Planning application no: 2021/94552

Land at, Barnsley Road, Denby Dale, Huddersfield HD8 8TS.

Erection of 53 dwellings and associated works

Comments for inclusion in the public consultation relating to the above planning application.

Appendix 6: Highways concerns adjacent site

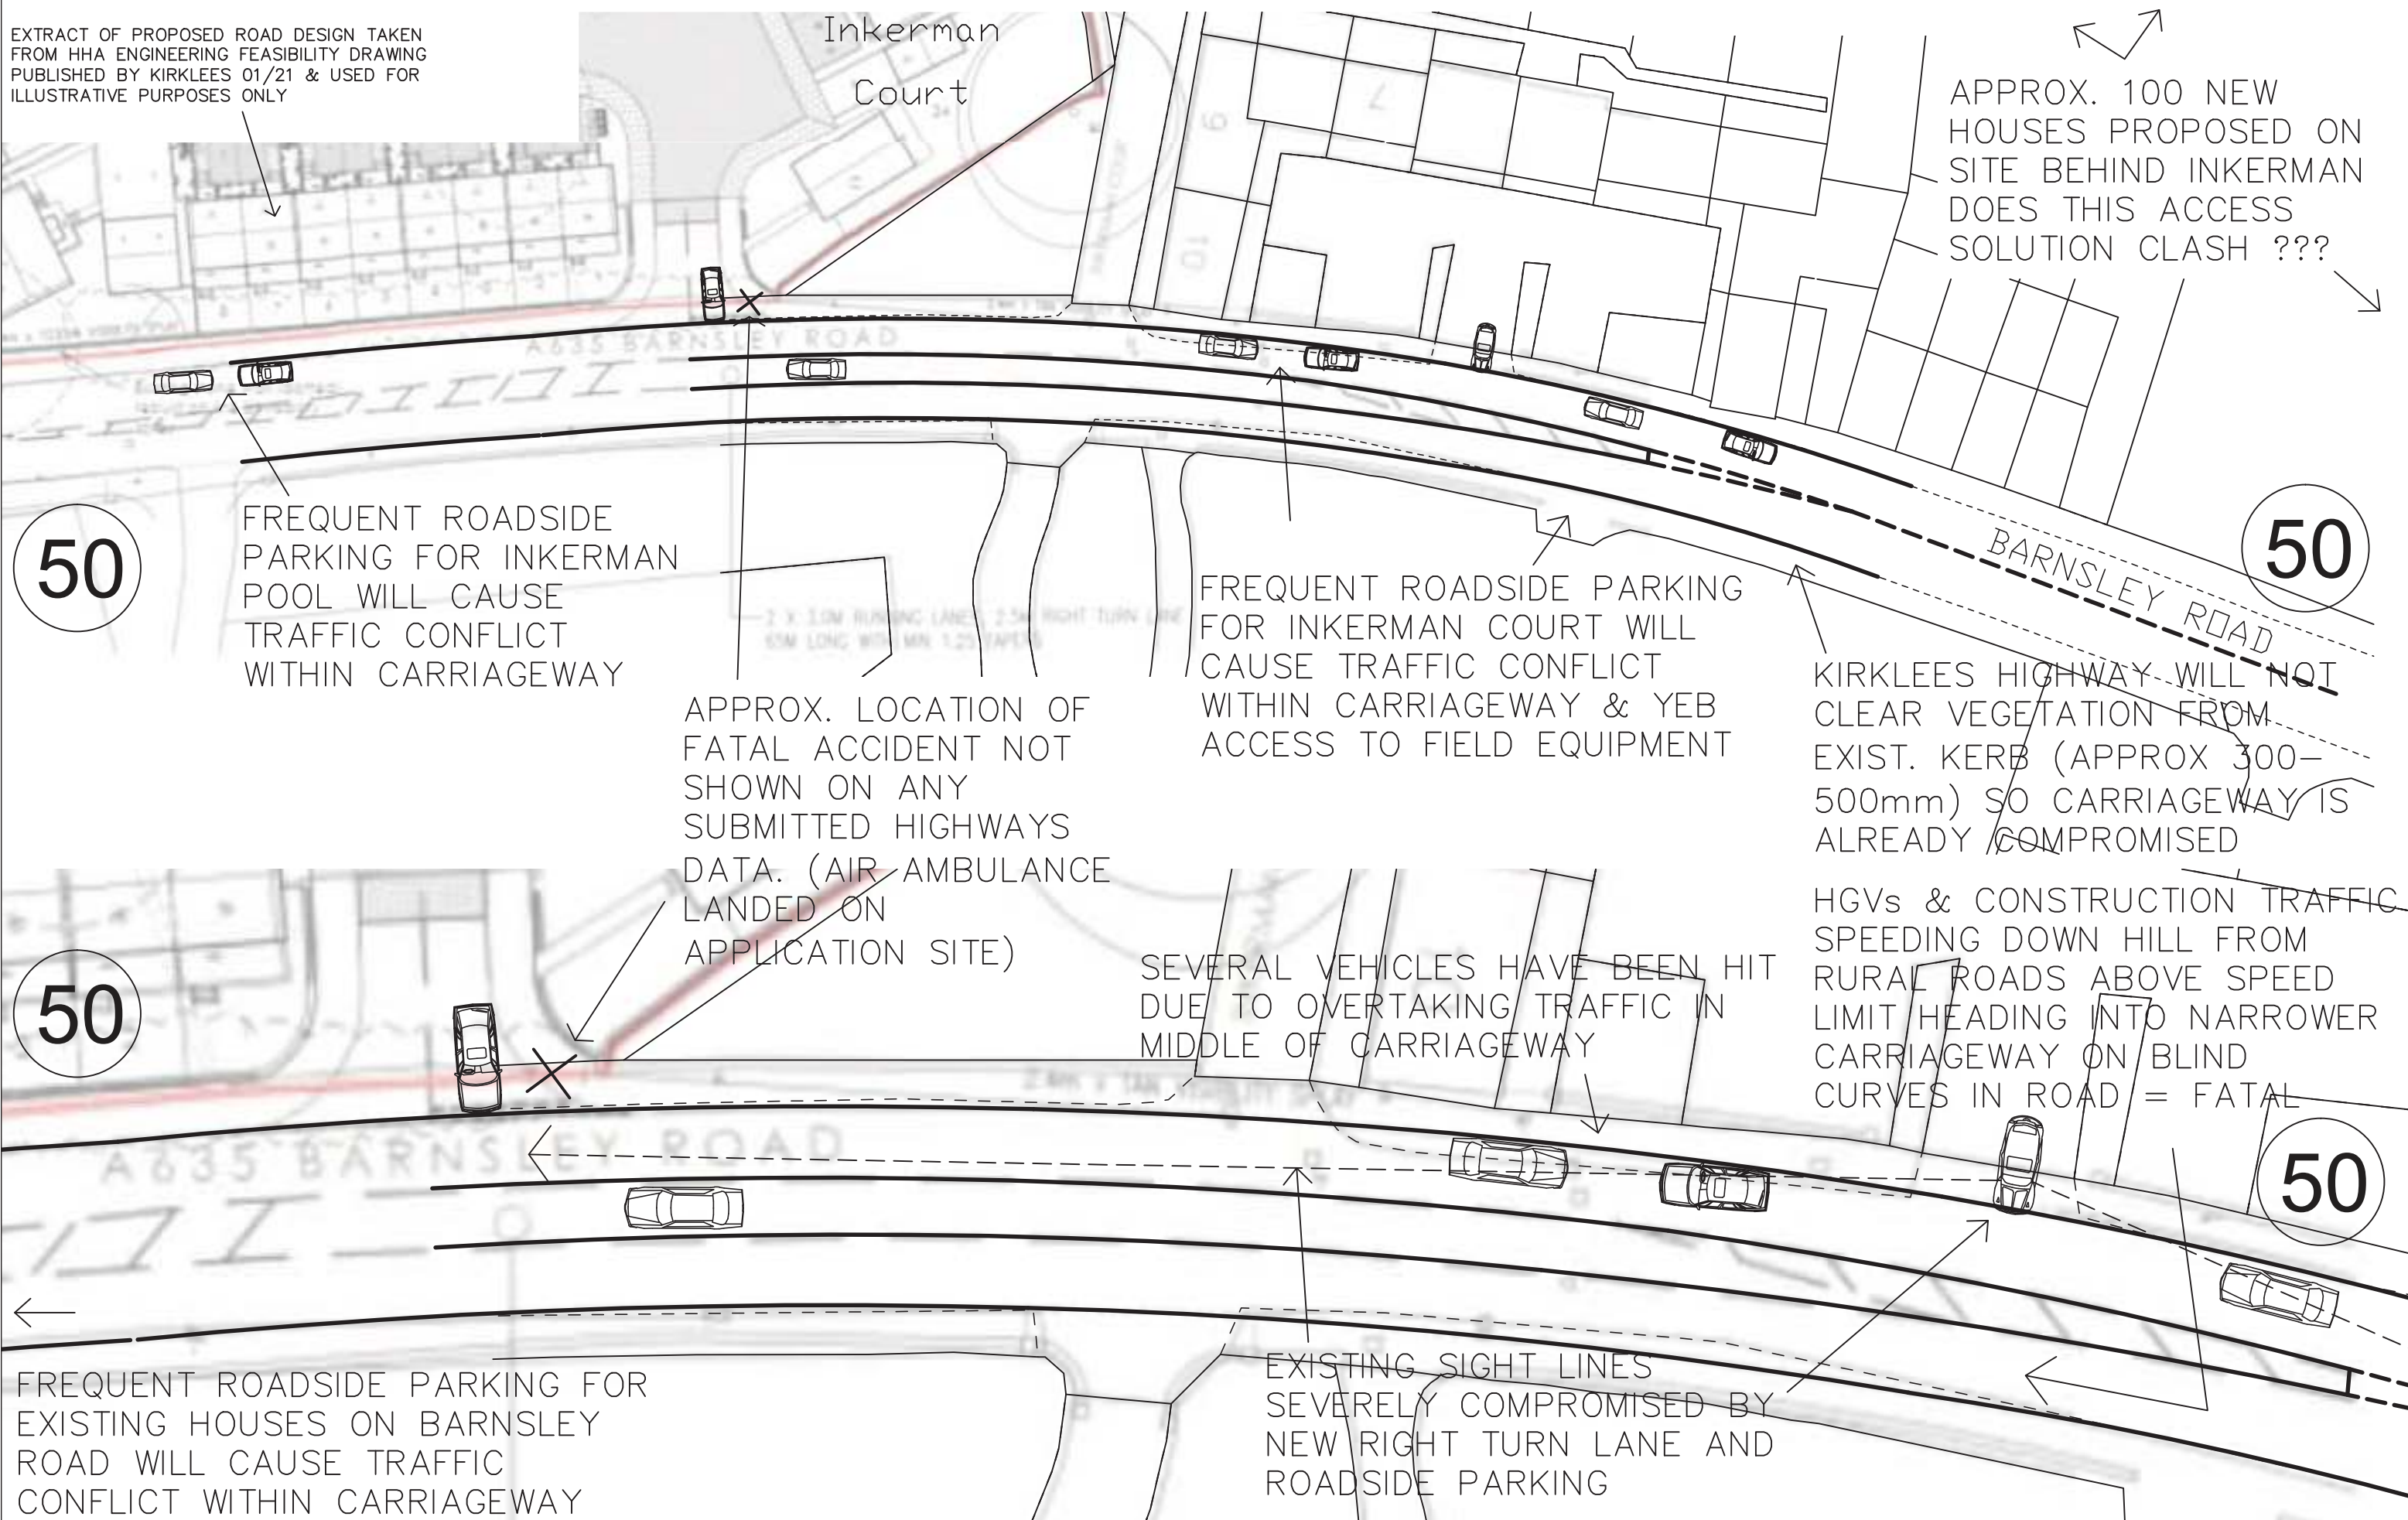
It should also be noted that very similar safety concerns were raised but not addressed by the Planning Process when the adjacent 34 unit planning approval (ref.2019-91836) and outline approval for 3 units directly opposite this Strata site (ref.2020-94314) was gained. Appendix 6 shows some of the primary concerns and it can be seen how this will affect the proposed access to the site under consideration.

These are all adding to what can be an extremely dangerous stretch of road. We would again request that all three of these sites are considered holistically so that a proper and robust solution can be found on this principal highway through a residential part of Denby Dale village.

EXTRACT OF PROPOSED ROAD DESIGN TAKEN FROM HHA ENGINEERING FEASIBILITY DRAWING PUBLISHED BY KIRKLEES 01/21 & USED FOR ILLUSTRATIVE PURPOSES ONLY

WHY are these trees being removed ? Extract from Submitted Landscape drawing P20-1107.001 Rev B

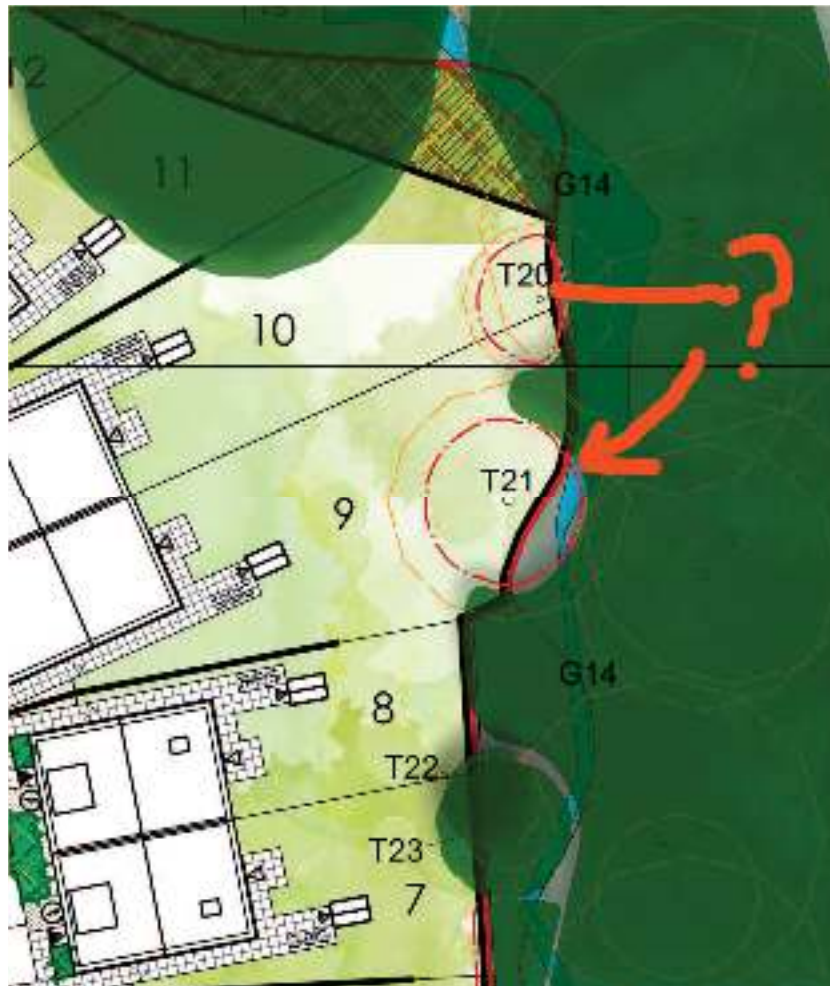
Trees/vegetation to be removed

Appendix 12: North Boundary retaining structure and materials issue

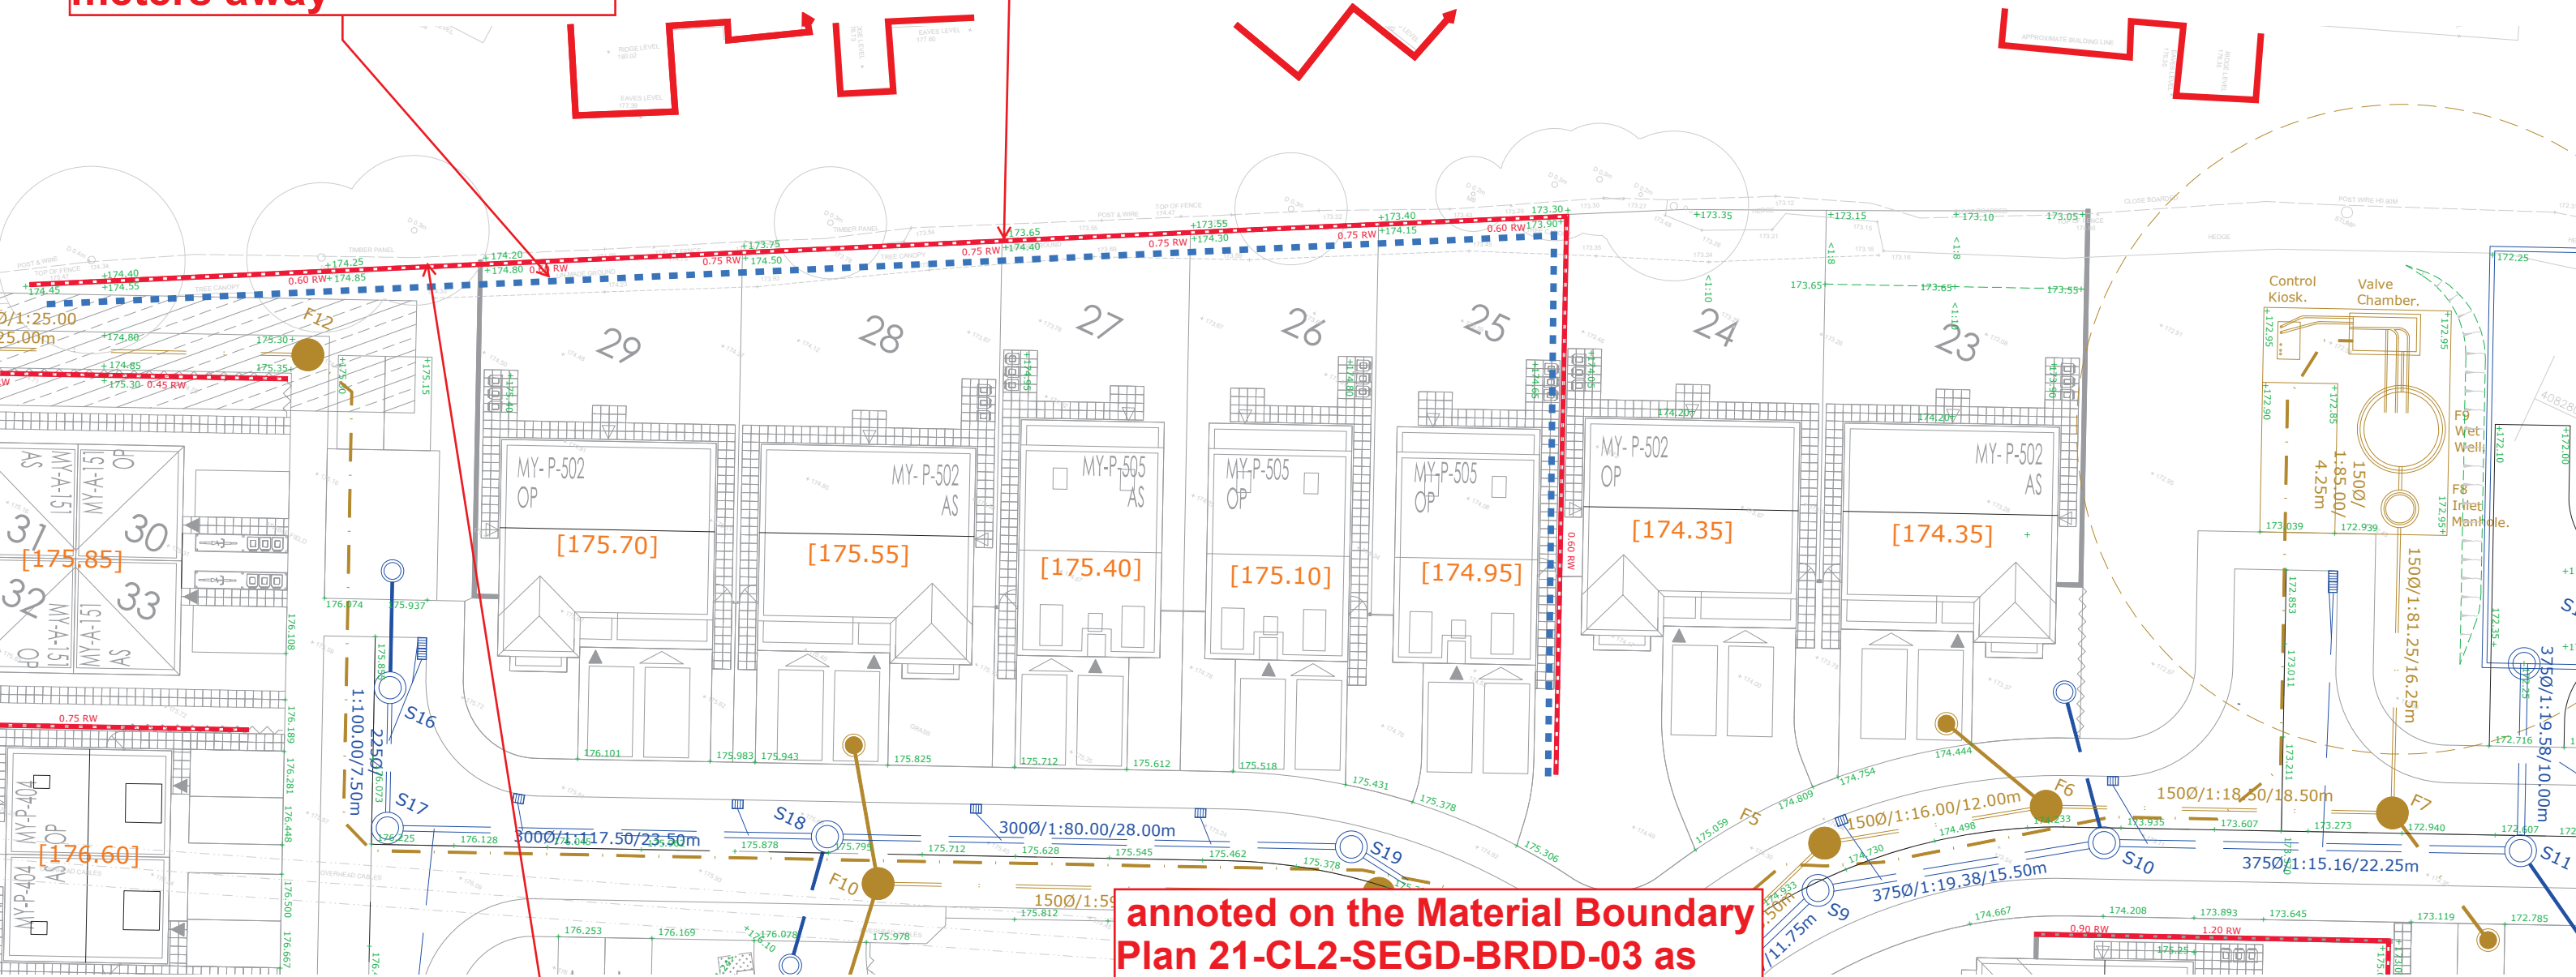
- b) Datums relating to the height of the proposed boundary fencing around the site (See Strata Material, Boundary & Surface Plan (ref 21-CL2-SEGD-BRDD-03 id908375) are missing and so the overlook impact cannot be assessed. There are also very few proposed levels indicated on the drawings provided and the application should not be determined without this critical information. We insist that this information is provided as a matter of urgency before the public consultation period ends. Specifically, finished floor levels at both ground, first and second floors are requested along with key levels to the boundaries as preliminary checks reveal the potential need for retaining structures and these are not indicated on the proposed layouts. See Appendix 12.

Datam to top of fence
176.60

but could be 177.2

no information on the boundary plan

annoted on the Material Boundary
Plan 21-CL2-SEGD-BRDD-03 as
1800 mm high fence
However the design is set in
concrete ground posts
